**KNOXVILLE/KNOX COUNTY METROPOLITAN PLANNING COMMISSION
SUBDIVISION REPORT - CONCEPT**

▶ **FILE #:** 11-SC-07-C

▶ **SUBDIVISION:** SHERRILL HILL

▶ **PROPOSED USE:** Mixed use subdivision

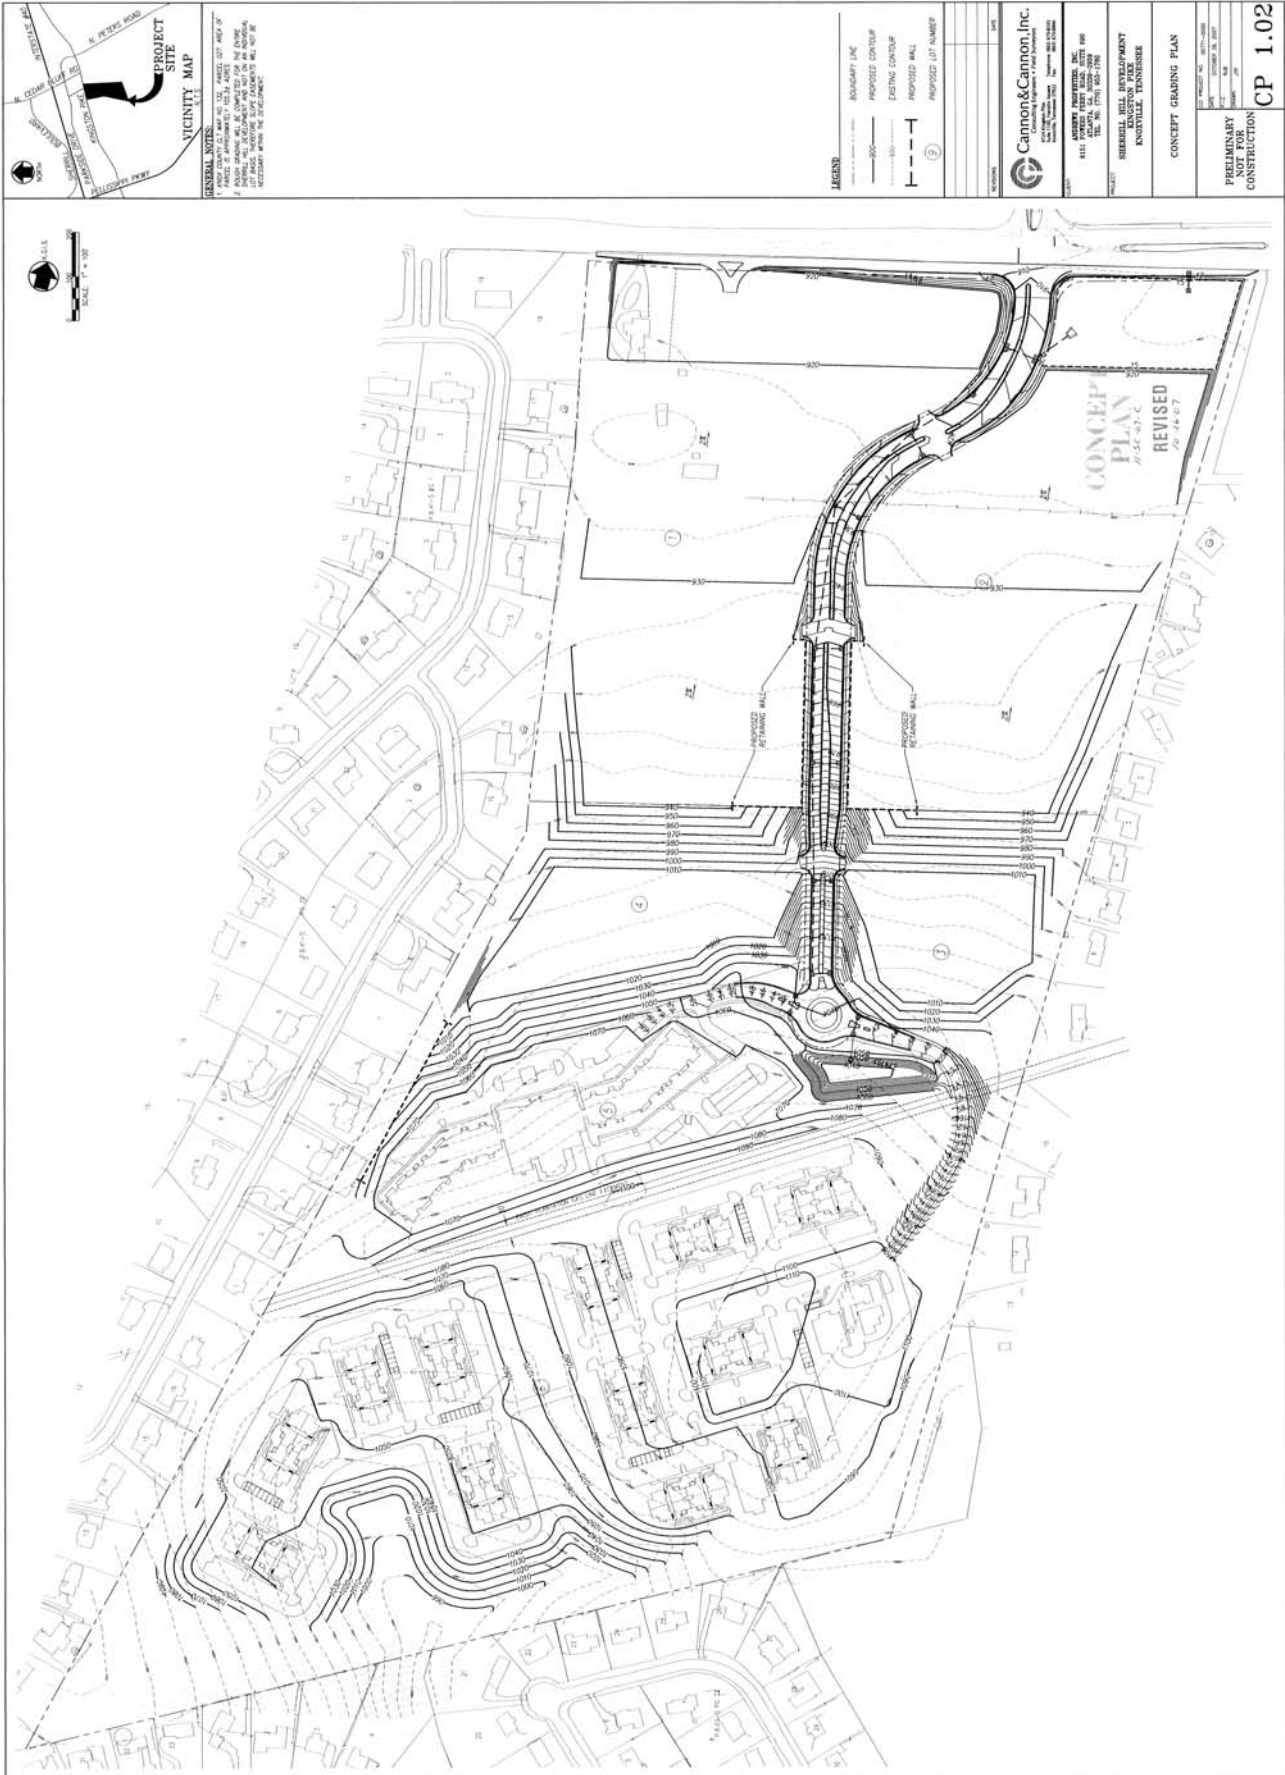
▶ **SUBDIVISION VARIANCES REQUIRED:**
1. Maximum street grade variance from STA 13+46.72 through STA 17+90, from 12% to 15%.
2. Vertical curve variance at STA 17+90, from 300' to 180'.

▶ **APPROVE** variances 1 and 2 because the site's topography restricts compliance with the Subdivision Regulations, and the proposed variances will not create a traffic hazard.

To get a better understanding of the grading that is needed to develop the site, Staff had requested that the applicant provide a preliminary site grading plan. This grading plan identifies the transitions needed between development sites and the grading that is proposed adjacent to the required 50' undisturbed buffer (condition of zoning approvals).

1. Connection to sanitary sewer and meeting any other relevant requirements of the Knox County Health Department.
2. Provision of street names which are consistent with the Uniform Street Naming and Addressing System within Knoxville (City Ord. 0-280-90).
3. Installation of the street improvements recommended in the Traffic Impact Study prepared by Cannon & Cannon, Inc. At the design plan stage of the subdivision, the applicant shall work with the Knoxville

- Engineering Division on the design, timing and implementation of the recommended street improvements.
4. Installation of the sidewalks as designated on the concept plan and in compliance with the requirements of the City of Knoxville.

5. Installation of the landscape plan designated for the boulevard as required by the Sherrill Hill Master Plan. Landscape plantings shall not interfere with sight distance for vehicles traveling on or entering the street.

6. Meeting all applicable requirements of the Knoxville Department of Engineering.
 7. Obtaining a street connection permit from the Tennessee Department of Transportation (TDOT).

8. Placing a note on the final plat that all lots will have access only to the internal street system except for Lot 1 that will be allowed the right-in/right-out curb-cut identified on the concept and as approved by TDOT.

9. Clearly marking in the field the 50' undisturbed buffer area that adjoins the existing residential neighborhoods prior to any clearing or grading beyond the clearing and grading required for the JPE. The dripline for specimen trees that are located within the buffer shall also be protected as outlined in the approved master plan (11-B-07-OB).
